December 13, 1988

Re: Septic System Design, Savereid; Market Hill Road
C.T. Male Associates Job #88-05071

PROJECT
JAY SAVEREID
 MARKET HILL ROAD
 AMHERST, HAMPSHIRE CO., MASSACHUSETTS

SHEET TITLE
**SUBSURFACE DISPOSAL
 SYSTEM DESIGN**

SECTION A-A
1" = 5'

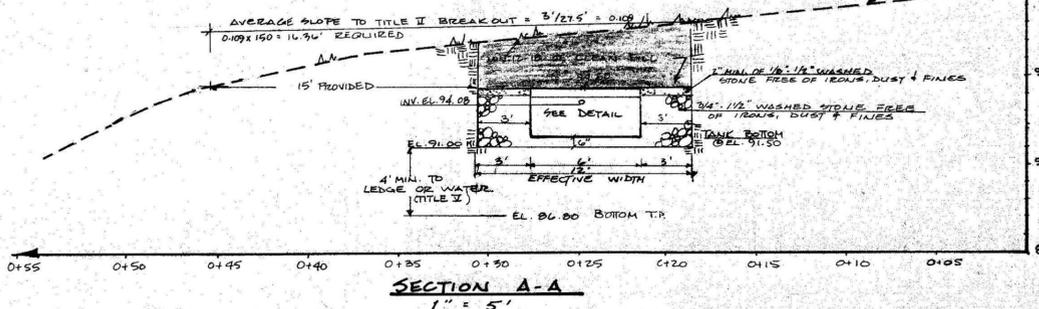
The proposed system was designed with concern for the topography of the site and Cushman Brook. To maintain the integrity and stability of the slope to the northwest of the system and house, a variance to Title V 15.12 Figure 1, Side Slope Requirement is needed. As shown on the plan, Section A-A, the slope is 0.109 and therefore a distance of 16.36' is required; a 15' distance is provided.
